project name: **RUSSELL GARDENS PHASE 3** municipality: **HAMILTON**

LOT SITING/GRADING

lot/block no.: **313**
registered plan no.: **62M-1266**
project no.: **19014**

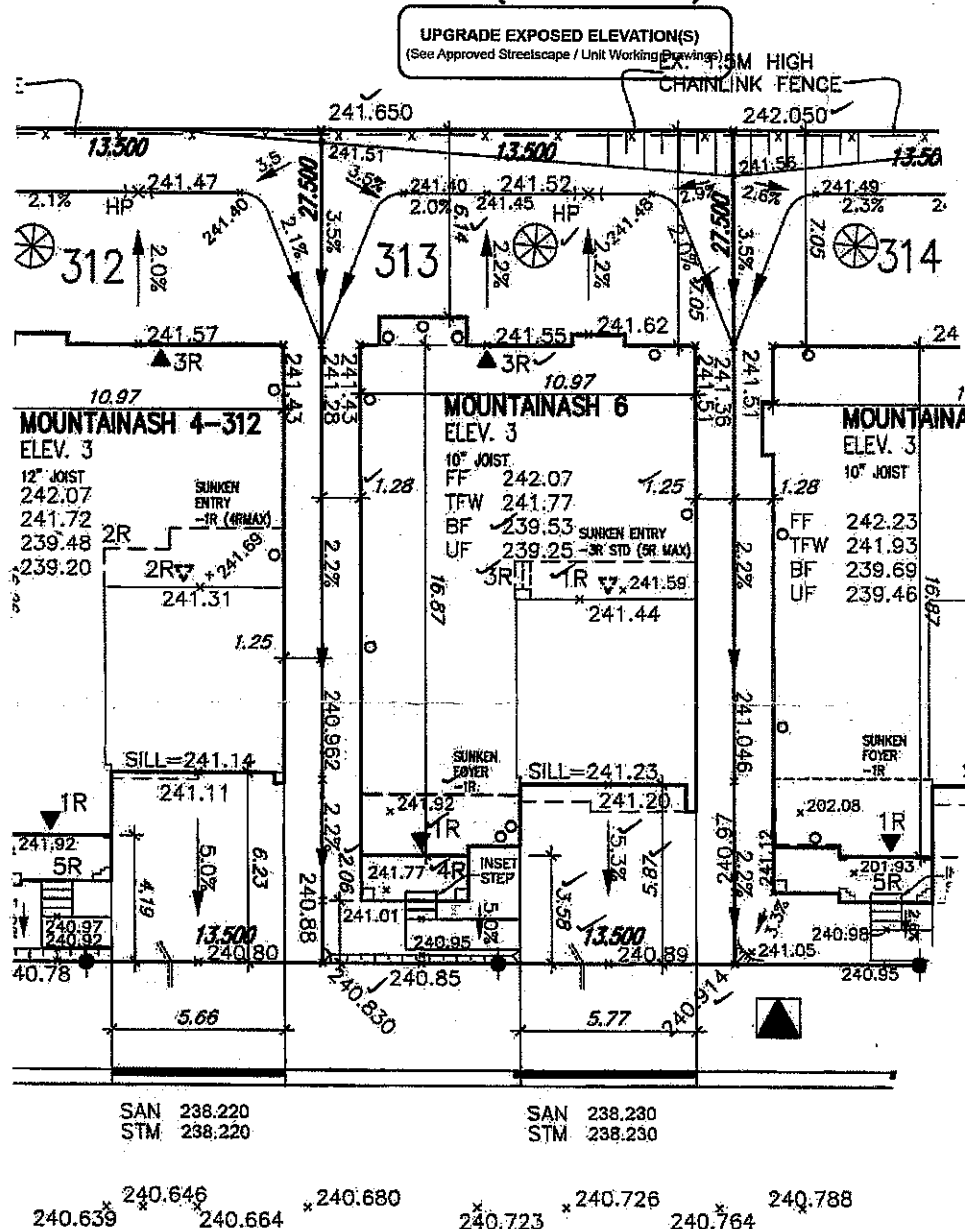
THIS LOT GRADING PLAN HAS BEEN REVIEWED BY METROPOLITAN CONSULTING INC. FOR CONFORMANCE WITH THE APPROVED SUBDIVISION GRADING DESIGN. THE PROPOSED GRADES ON THIS PLAN ARE IN GENERAL CONFORMANCE WITH THE APPROVED GRADING PLAN AS IT RELATES TO THIS LOT AND ADJACENT LOTS. WHERE THE BASEMENT FLOOR OR OTHER FOUNDATION ELEVATIONS ARE PROPOSED AT A DIFFERENT ELEVATION THAN THAT SHOWN ON THE APPROVED SUBDIVISION PLANS THE SEWER LATERALS HAVE BEEN REVIEWED AND WE ARE SATISFIED THAT THE MINIMUM GRADES FOR THESE LATERALS CAN BE MAINTAINED IN ACCORDANCE WITH THE REQUIREMENTS OF THE O.B.C. AND CITY DESIGN CRITERIA. NOTE: THIS CERTIFICATION DOES NOT REPLACE THE BUILDER'S RESPONSIBILITY TO EXPOSE THE SEWER LATERALS AND CONFIRM ELEVATIONS PRIOR TO EXCAVATING FOR THE FOUNDATION. BY USE OF THIS PLAN THE BUILDER AGREES THAT THEY SHALL BE RESPONSIBLE FOR IMMEDIATELY REPORTING TO METROPOLITAN CONSULTING ANY DISCREPANCY OR VARIATION BETWEEN THE LATERAL INFORMATION AND GRADES DEPICTED ON THIS PLAN AND THE CONDITIONS FOUND IN THE FIELD.

A SEPARATE PERMIT IS
REQUIRED TO CONSTRUCT
A REAR DECK.
